# City of Richmond

## Report to Committee Planning and Development Department

**Re:** Application by Matthew Cheng Architect Inc. for Rezoning at 7751 Heather Street from Single Detached (RS1/F) to High Density Townhouses (RTH2)

Drawing No. **A3.1**  
 Revision Date: **March 24, 2015**  
 Print Date: **March 24, 2015**

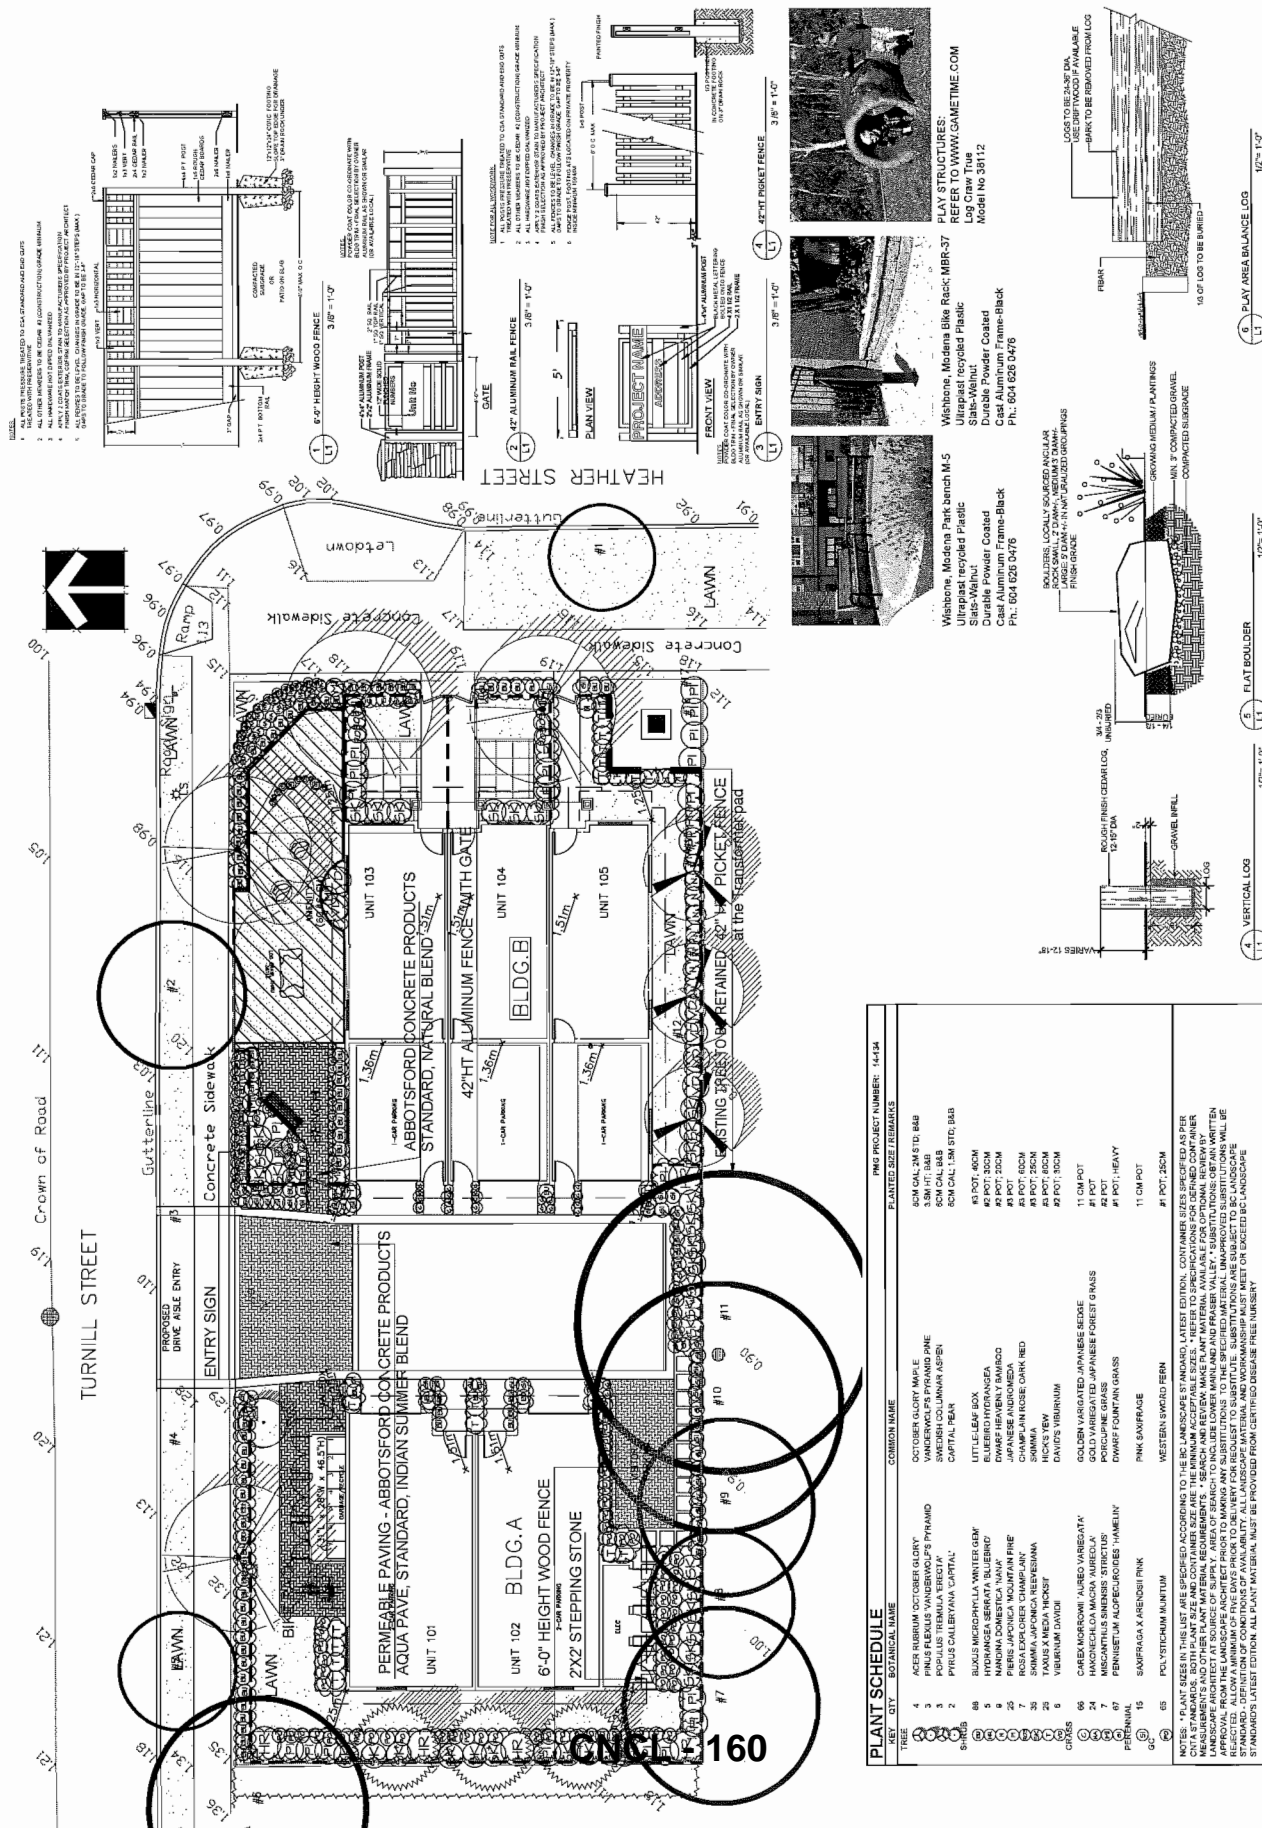
- Refining proposed fenestration and architectural elevations through the use of treatments that better promote recognition of individual storeys to reduce the apparent height of the proposed buildings (e.g., using colour and materials to give buildings a distinct top, middle, and base).
